UNITED STATES PATENT AND TRADEMARK OFFICE

Office Action Summary	Application No. 10/803,730	Applicant(s) BUSAM ET AL.	
	Examiner SARA ADDISU	Art Unit 3724

DETAILED ACTION

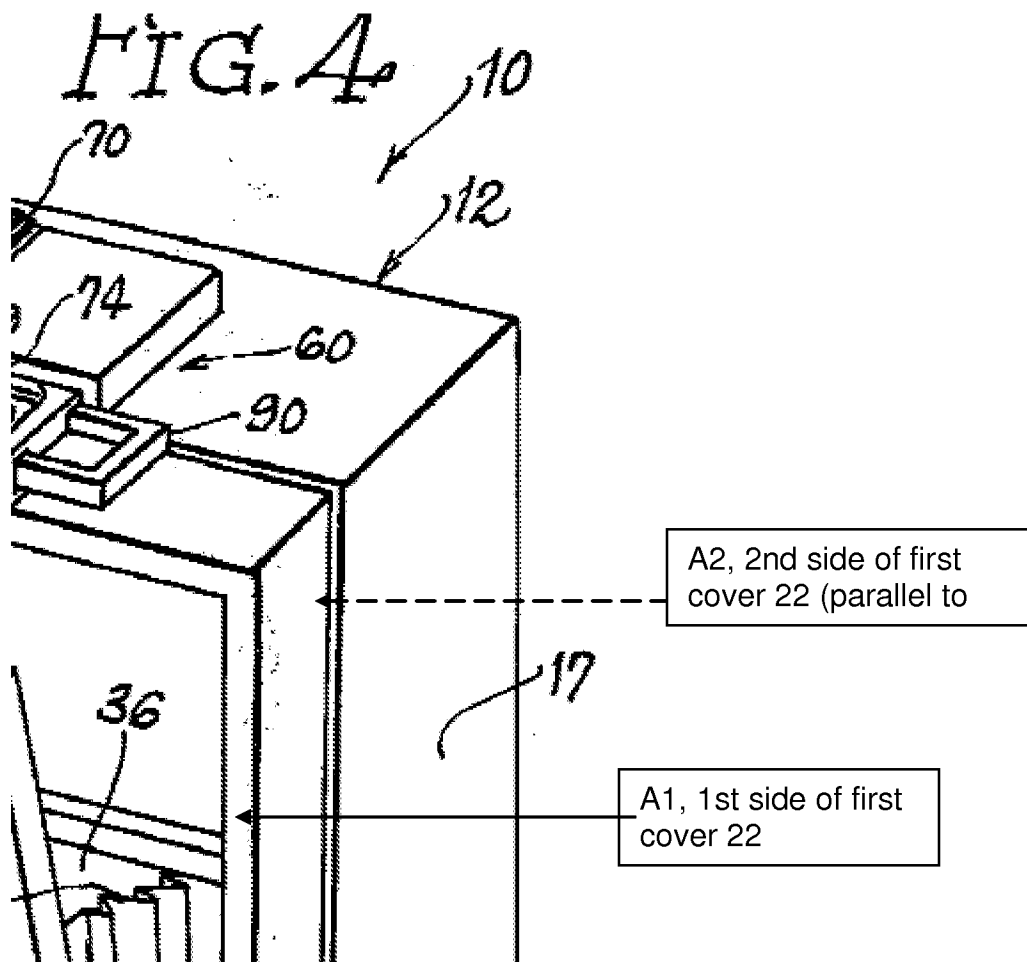
7. Claim 51, as best understood, is rejected under 35 U.S.C. 102(b) as being anticipated by Malooly (USP 3,912,055).

MALOOLY teaches a first generally planar cover/component (22) pivotally coupled to a second generally planar cover/component (12), both of said covers being generally flat and planar; said first cover/component including an opening (36) and having a first side (A1) and a second side (A2 being parallel to A1: see figure below); and a pocket coupled to said first planar cover/component and generally received in said opening, said pocket including a front/first panel (26) and a second/rear panel (42) defining a pocket cavity there between, said first/front panel (26) being larger than said opening (see figures 1 and 4) and at least portions or tabs (54) of the second panel (42) extending outwardly/to the side beyond said opening (see figures 1-4 and col. 3, lines 5-20). Furthermore, regarding claim 22, MALOOLY teaches the second panel (42) is preferably provided with stop means to engage the ledges or stop elements (50), so as to prevent the second panel (42) from swinging out of the first cover (22) ('055, col. 3, lines 7-10). Figure 1, shows the first/front panel (26) pivoting independently and figure 3 shows the second/rear panel (42) pivoting independently. MALOOLY also teaches a first releasable fastening mechanism (32) positioned to releasably join said first panel (26) and said first side of said first cover (22) (see figures 1 and 4). MALOOLY also teaches in figure 1, the pocket and its cavity being accessed from the outside and in figure 3, the pocket being accessed from the inside of the first cover. MALOOLY also teaches when the first panel fastening mechanism (32) is undone, the first/front panel (26) can be pivoted away from the front cover/component (22) to its position shown in figure 1 whereby this configuration, the first panel (26) pulls the side panels (46) and portions of the pocket and pocket cavity through the opening (36) of the front cover (22)

such that generally all of the pocket cavity is located on the first side (A1) of the first cover (22) and generally no portion of the pocket cavity is located on the second side (A2) of the first cover (22) thus, portions of the pocket and pocket cavity are pulled to the first side (A1) of the first cover (22) such that the pocket cavity can be accessed and components can be placed into and removed from the pocket /pocket cavity by a user without having to reach through or break a plane formed by the first cover (22).

Similarly, when it is desired to access the pocket from the second side (A2) of the first cover (22), the second panel (42) is pivoted inwardly (as shown in figure 3) thereby pulling portions of the side panels (46) and pocket cavity through the opening (36) such that in this manner, portions of the side panels (46) and pocket cavity are located on the second side (A2) and inwardly of the plane of the first cover (22) so that components can be added to or removed from the pocket cavity without a user having to reach to the first side (A1) or reach across or break the plane of the first cover (22). In this position, generally the entire pocket cavity is located on the second side (A2) of the first cover (22). Please note that, although MALOOLY is a suitcase and not a binder, Examiner stresses that it functions the same way as a binder which is to act as a means of storage thus reads on the claims. Furthermore, MALOOLY teaches said rear/second panel (42) being located on the inner side of the first cover/component while the front/rear panel (26) being located on the outer side of the first cover/component (see figures 3 & 4).
